PCS Responses to comments below:

Re: Second Submission Review – Urban Cottages Jewell – Zoning Map Amendment, Site Plan w/Adjustment and Final Plat
Application Number: **DA-2309-00**
Case Numbers: **1984-2057; 2022-4026-00; 2022-3022-00**

URBAN COTTAGES JEWELL SITE PLAN

SHEET NUMBER
SP1
2 OF 29

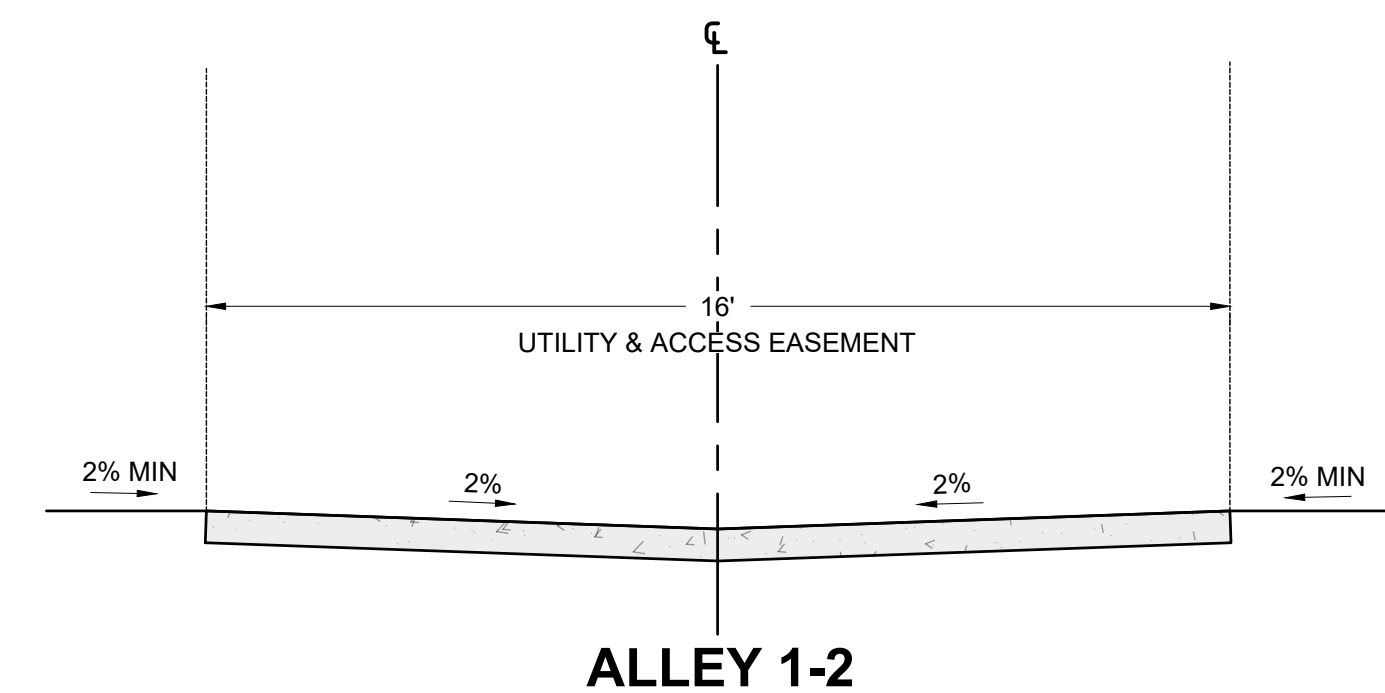
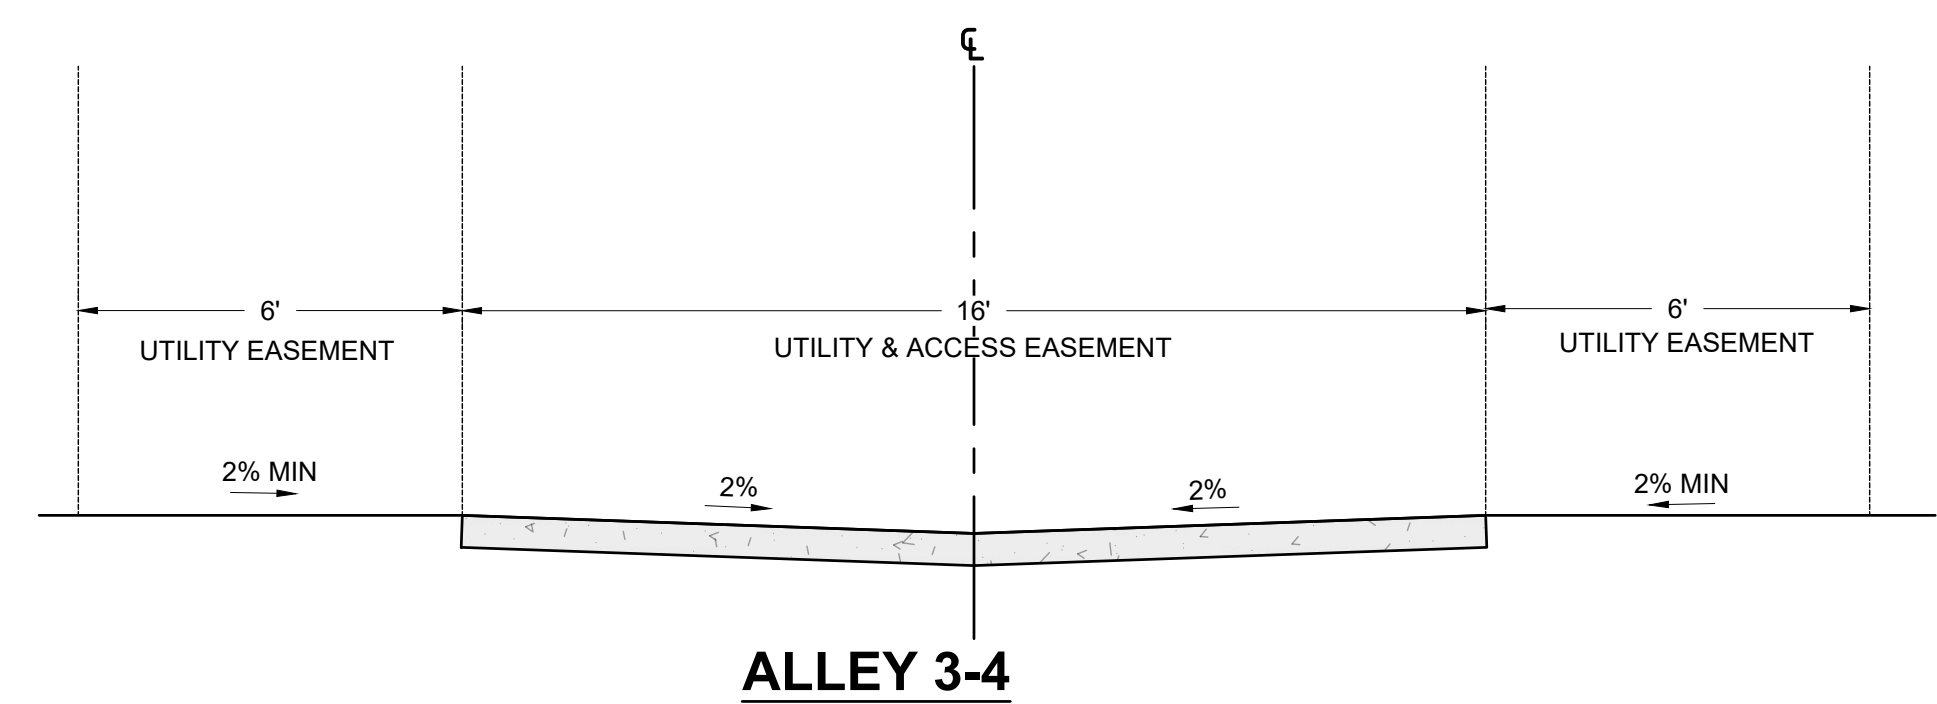
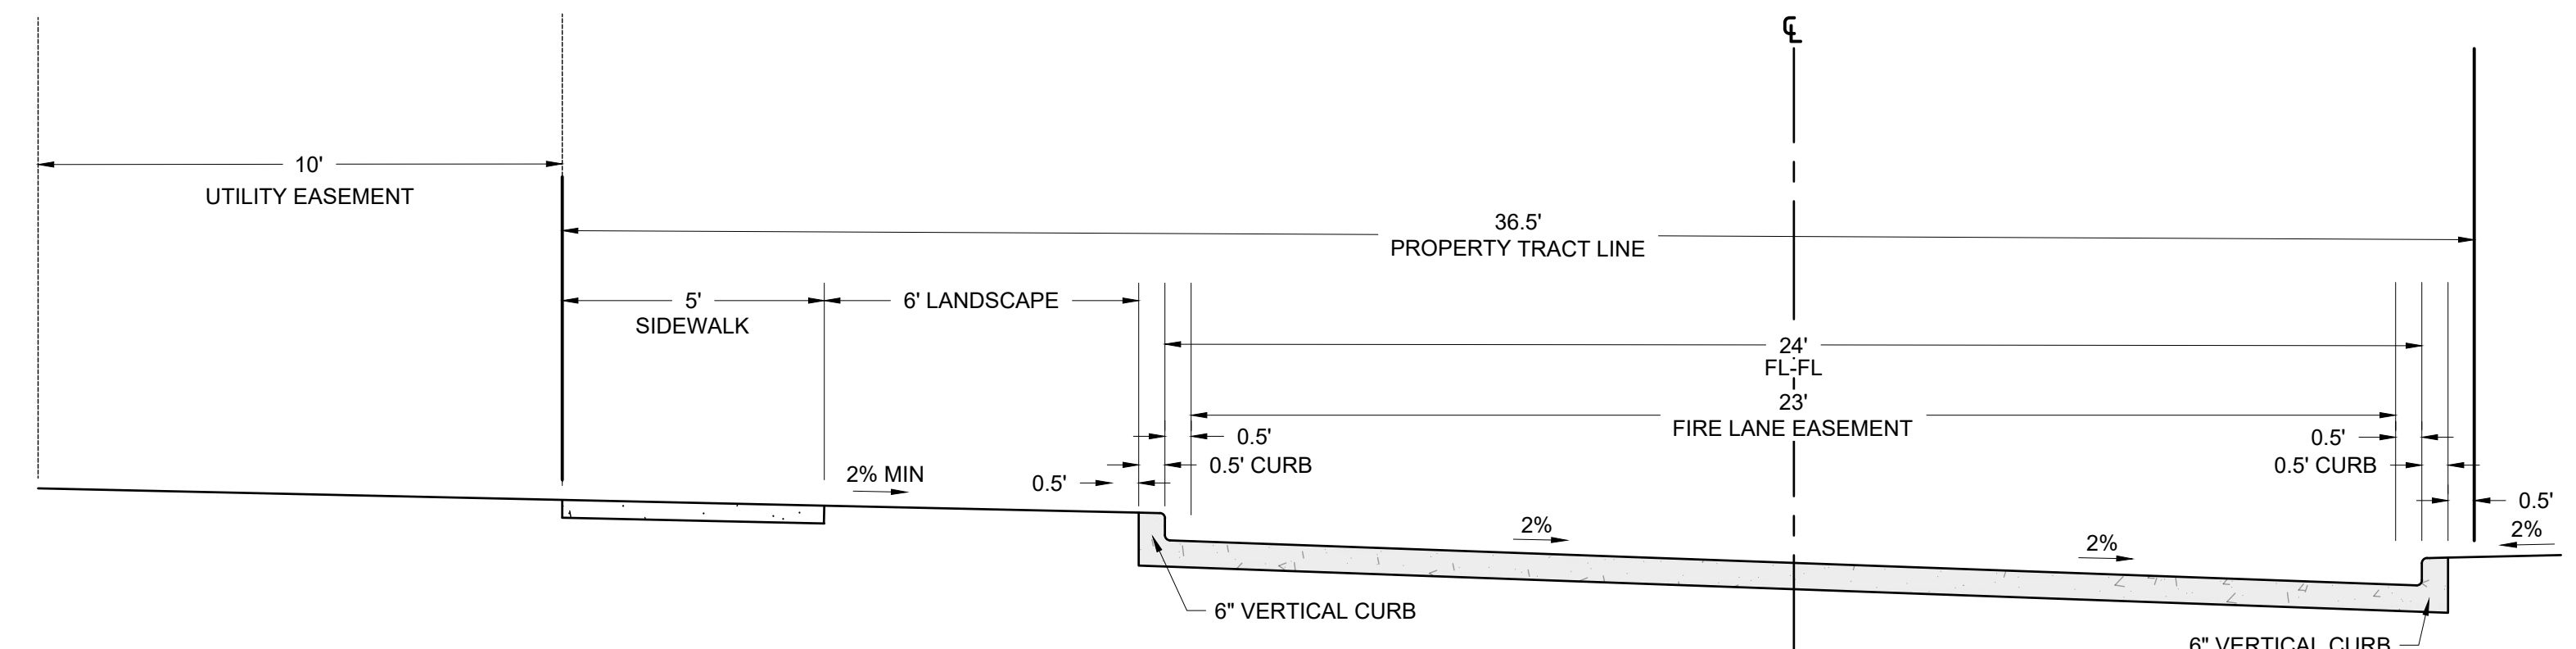
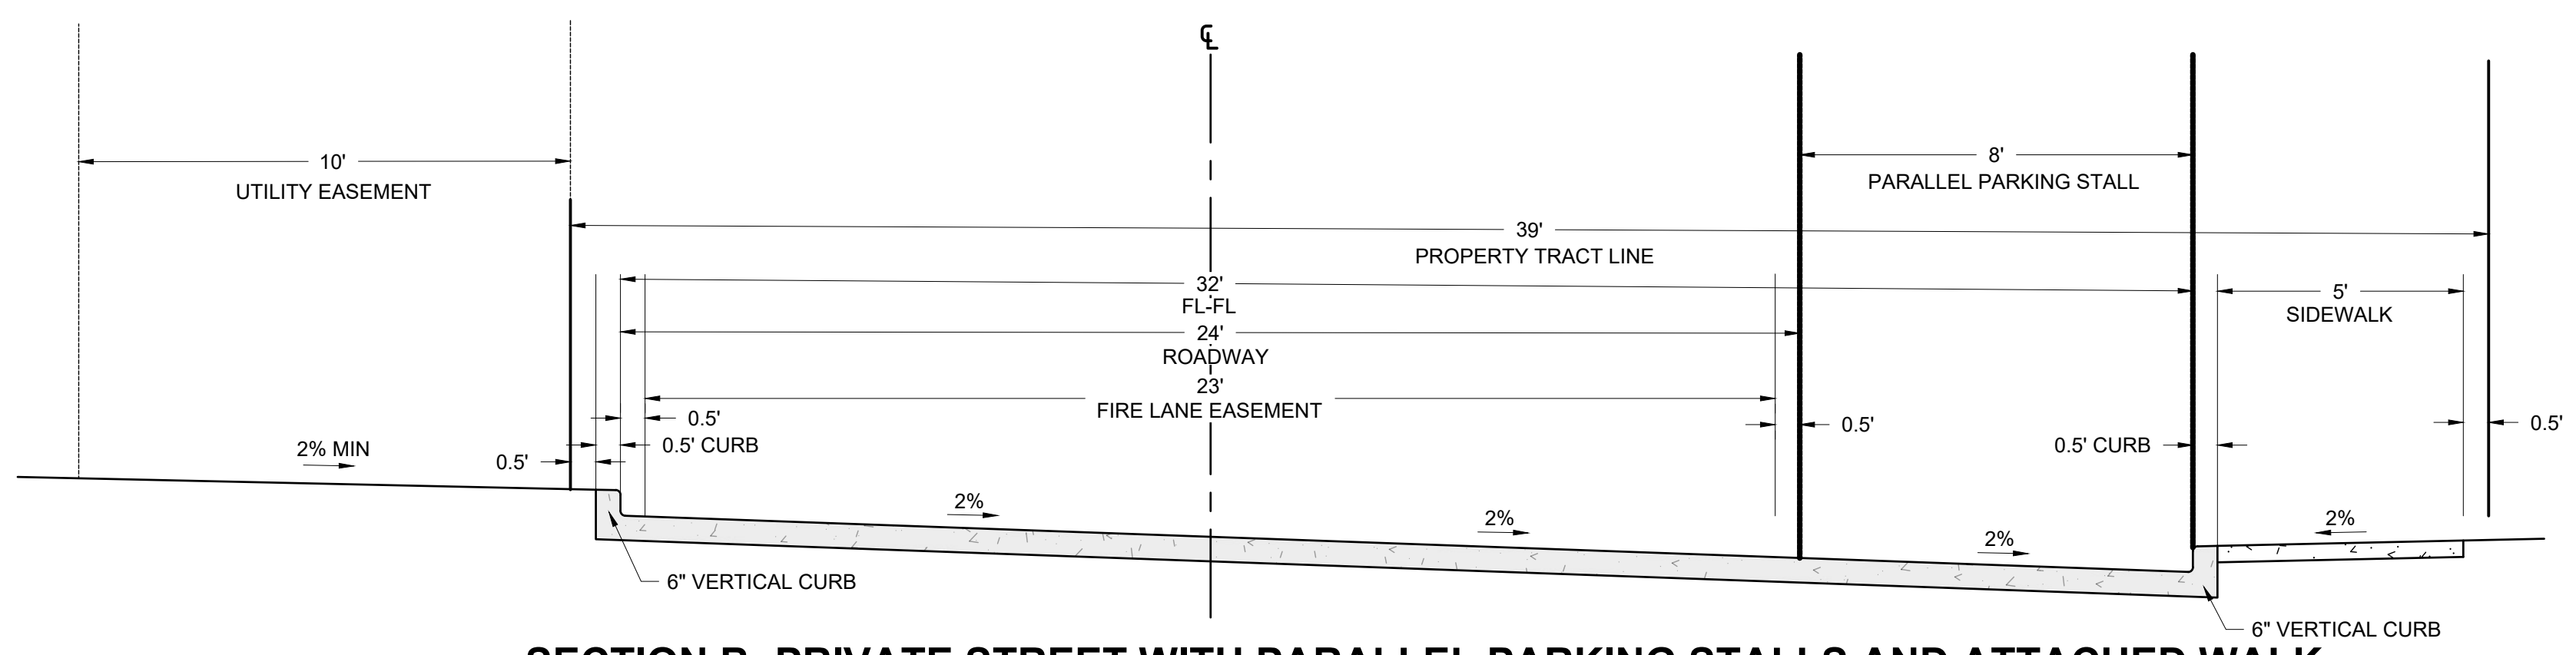
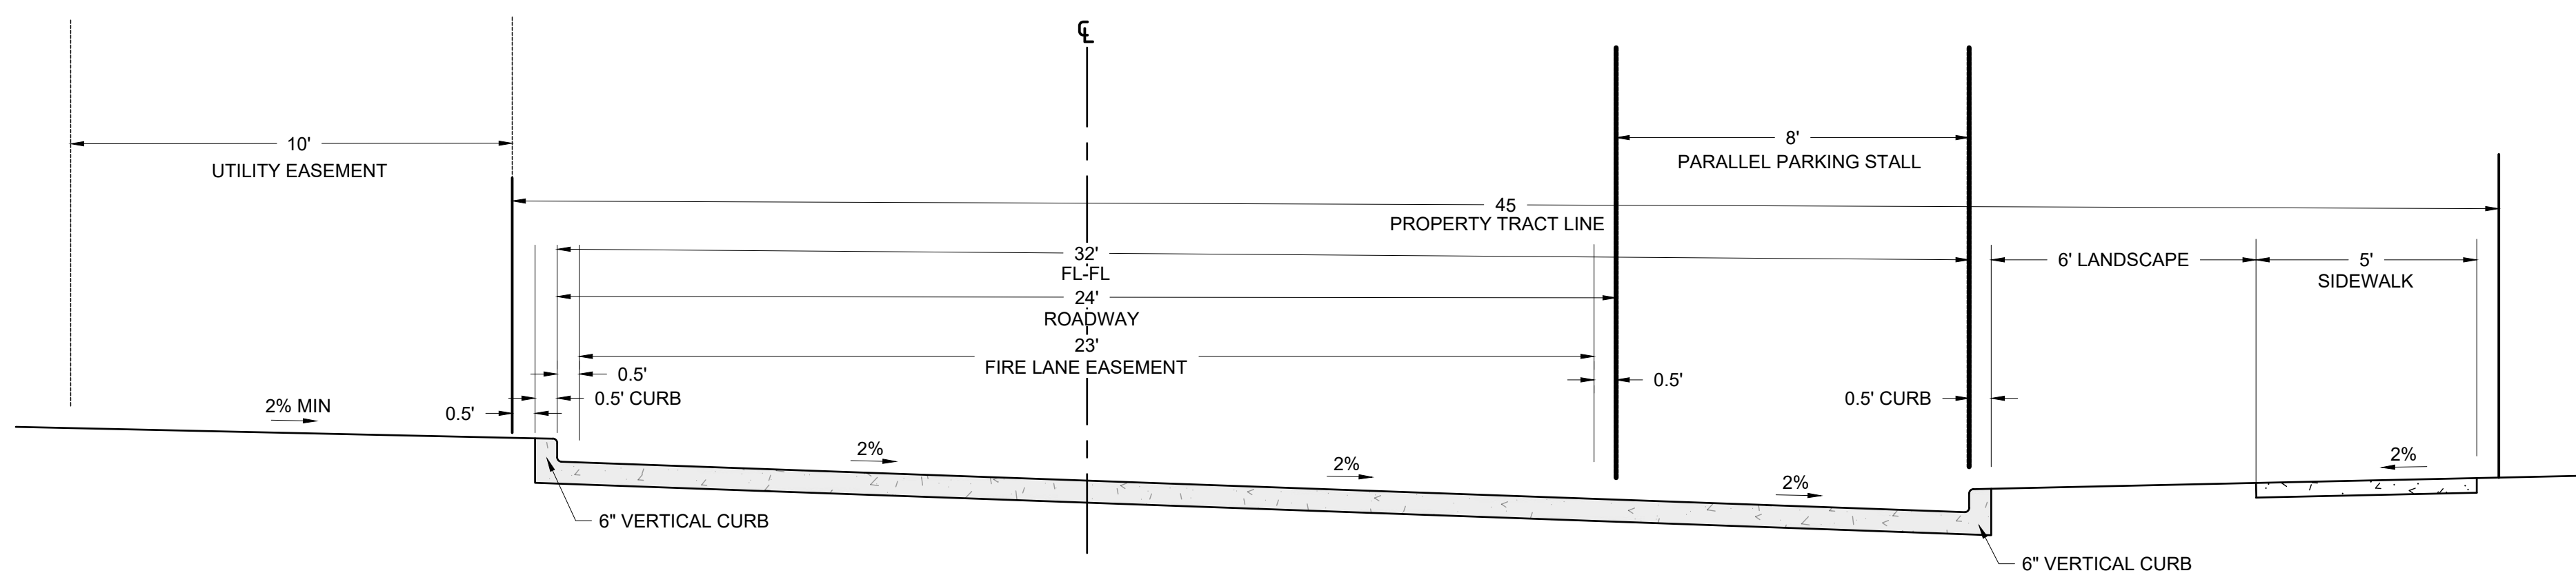
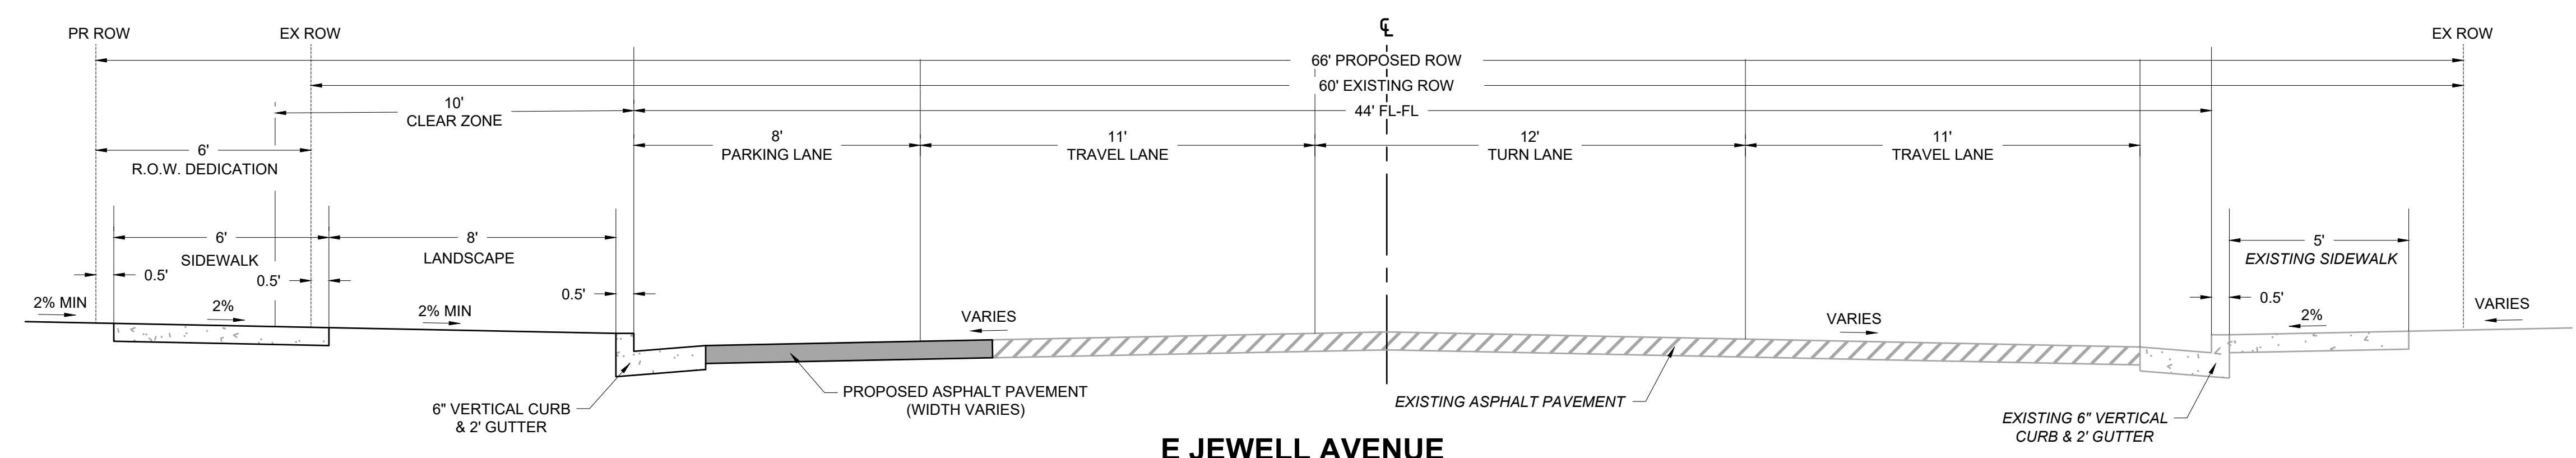
The flowline should match the existing flowline to the east. The comment response mentions that this was not done based on conversations with staff. Was this discussed at the meeting in April? Or with a separate staff member?

Identify this alley as a drainage easement due to capturing more than 2 1/2 lots of stormwater flows

Label crossspans, typical.

Revised as requested.
